**HISTORIC PRESERVATION REVIEW BOARD  
STAFF REPORT AND RECOMMENDATION**

Landmark/District: **Georgetown Historic District** (x) Agenda  
Address: **1051/1055 29<sup>th</sup> Street NW (West Heating Plant)**

Meeting Date: **November 2, 2017**  
Case Number: **17-633** (x) Demolition

Heating plant under construction showing steel framing

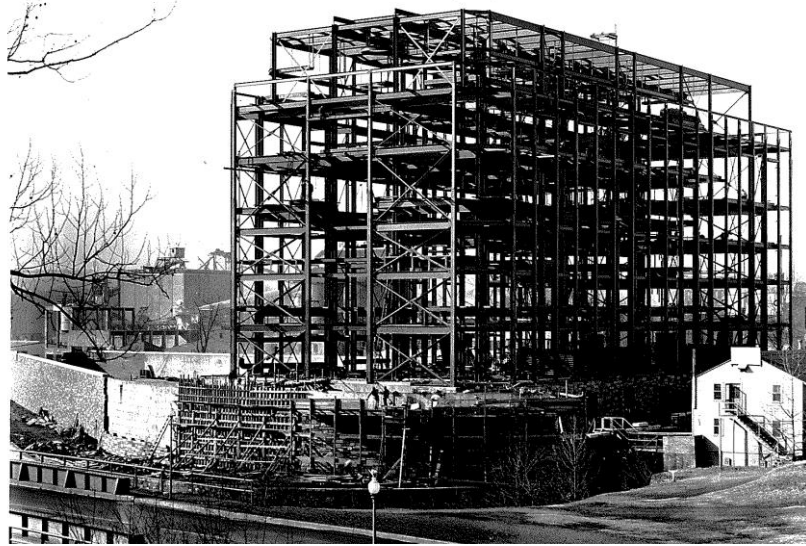
Structural engineering reports do not conclude that the building is near collapse.<sup>3</sup> In evaluating the steel structure (photograph above), the engineers note the presence of rust scale at the base of the cavity in which the steel stands. It is not unusual for steel to rust when exposed to moisture, but the reports do not cite significant loss of bearing capacity as the major concern. Instead, inadequate lateral bracing, the effect of rust jacking on the brick walls, and inadequate structural capacity to support a new floor structure are among the issues cited. The reports discuss ways that these conditions could be addressed by appropriate repairs, reinforcement, improved moisture control, and insertion of new structural elements as part of rehabilitation.
